TOWN OF FAIRFAX

Permit #20-T-09

NOTICE OF TREE COMMITTEE ACTION

PEOPLES RESIDENCE

A1.5

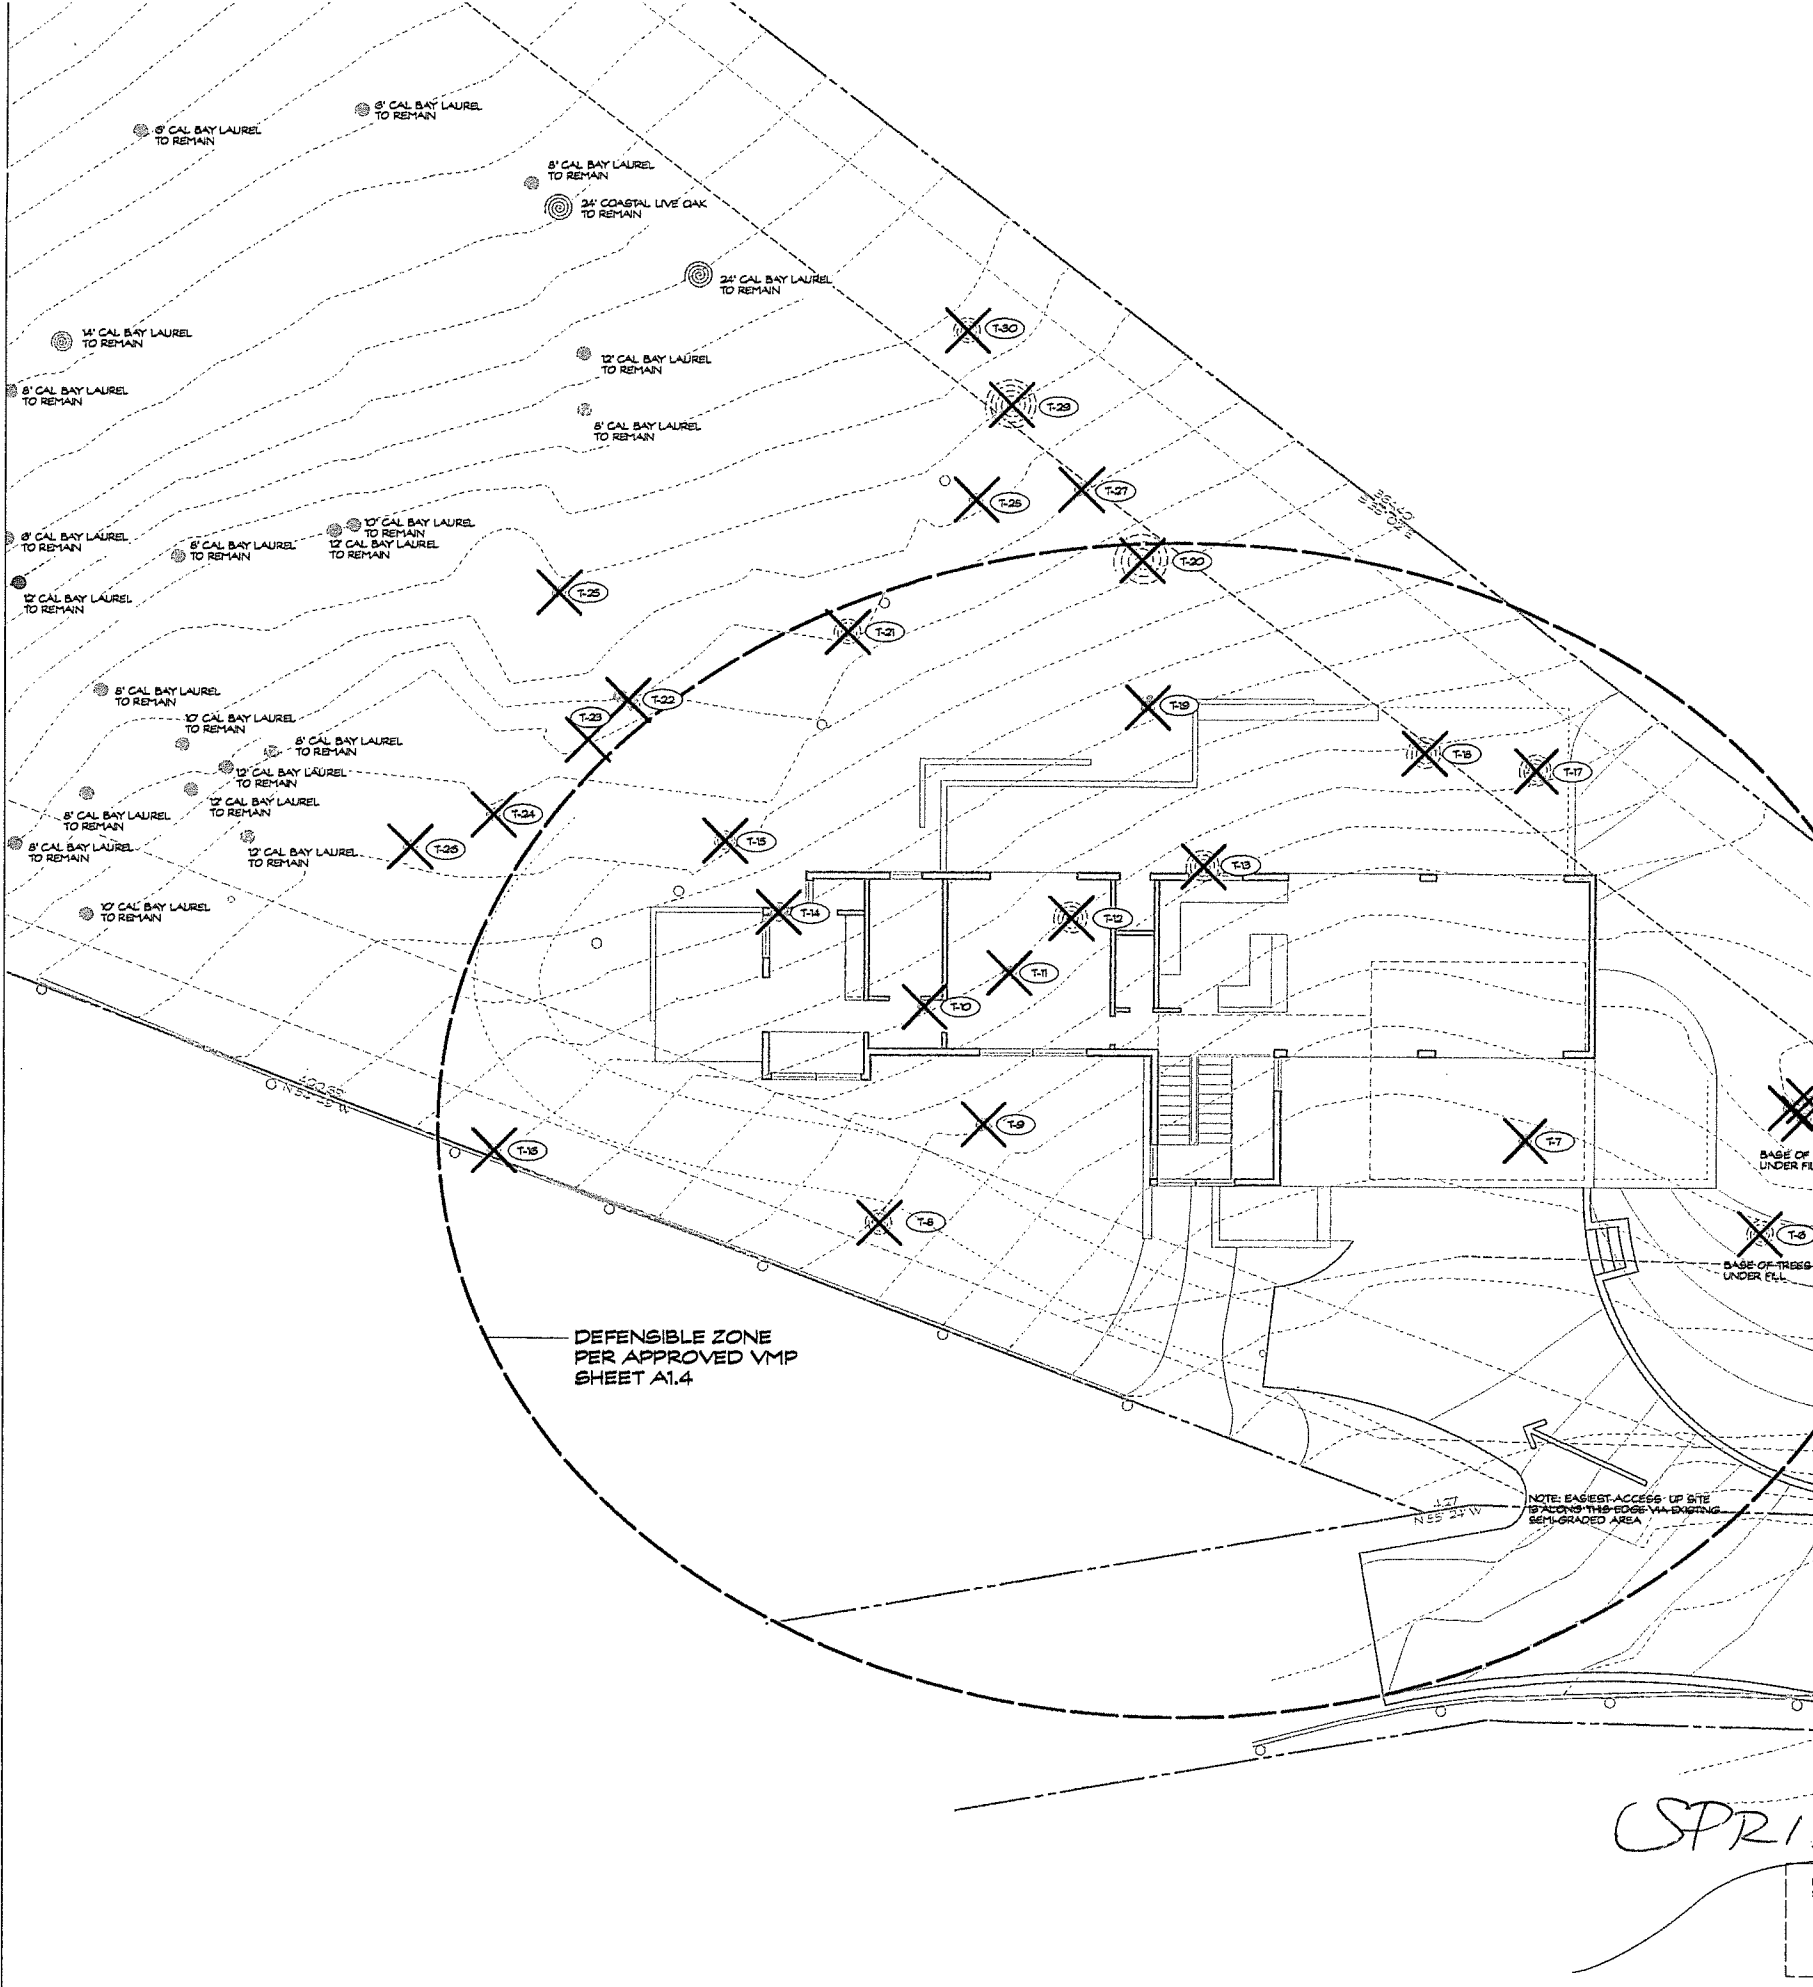
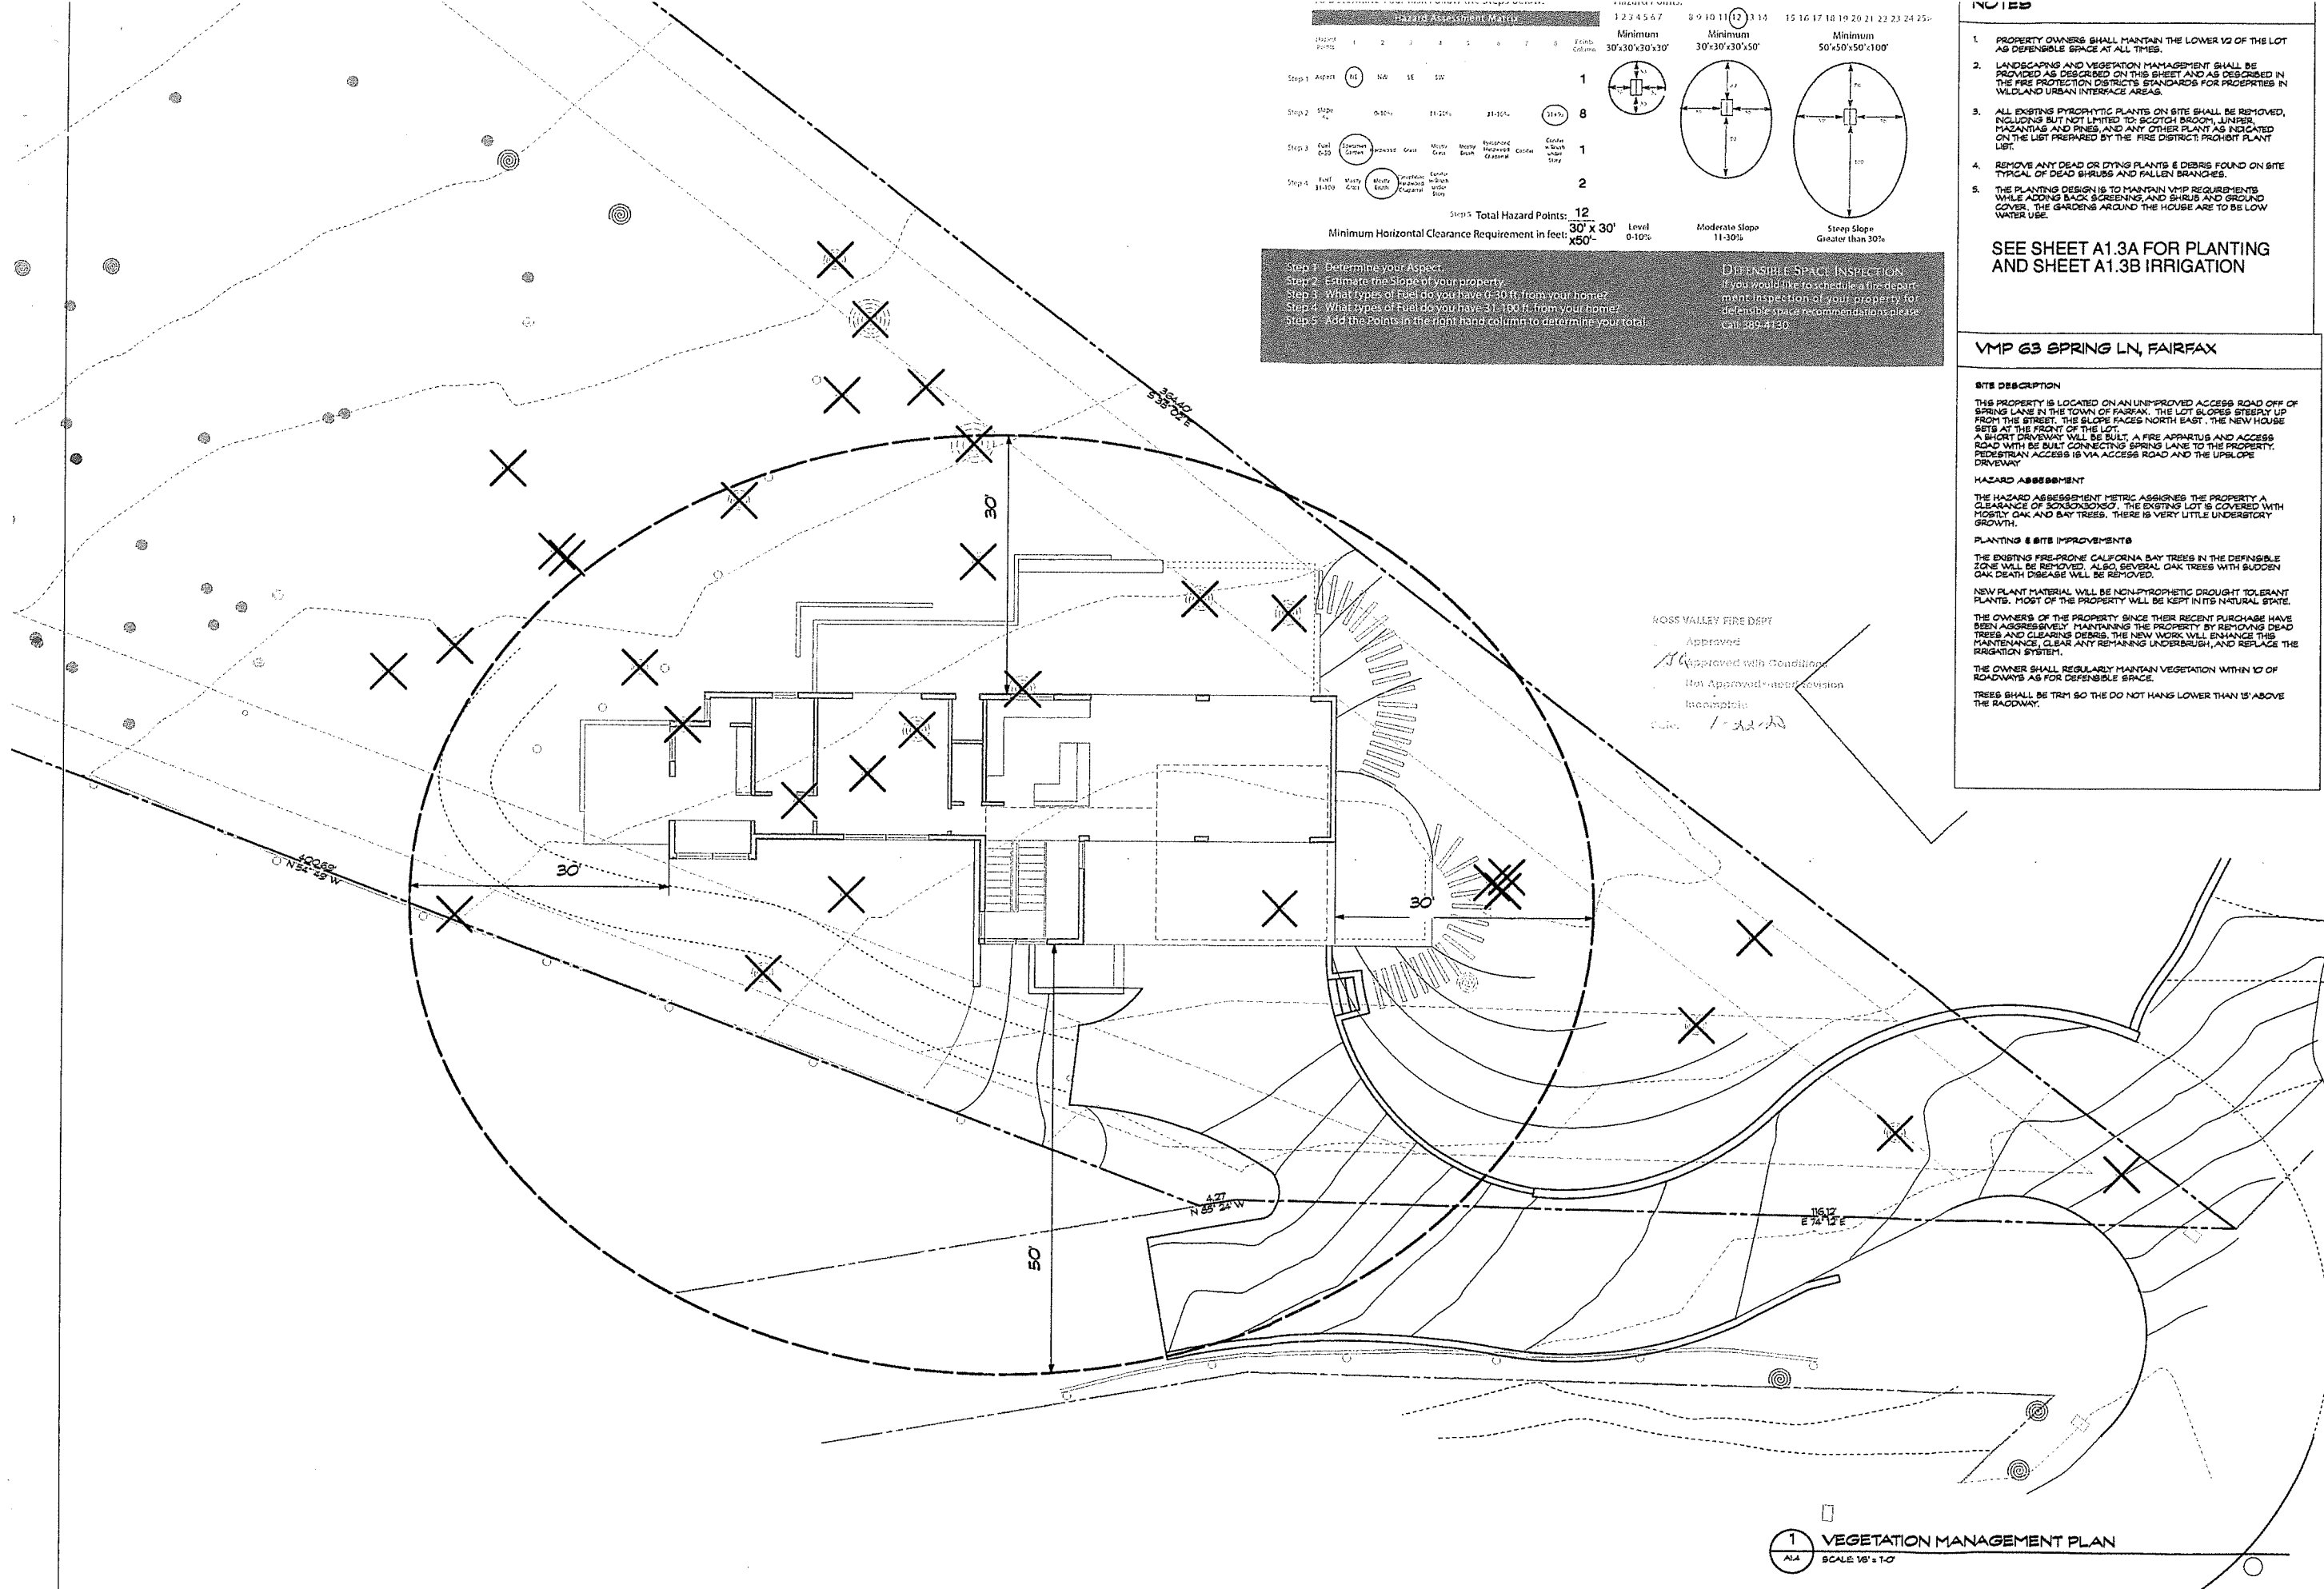
Romaidis made a motion to recommend that the species of tree T-6 on the VMP be verified due to the fact that it appeared to be misidentified. The Committee would like the non-diseased trees that are outside of the 100 feet of defensible space that are identified to be removed be replaced at a minimum 1:1 ratio. A landscape plan was provided and it appeared to satisfy the Committees desire for replanting. Additionally, the Committee recommends that the replanting be done prior to issuance of a Certificate of Occupancy (C of O). The motion was seconded by Richardson Mack and voted on.
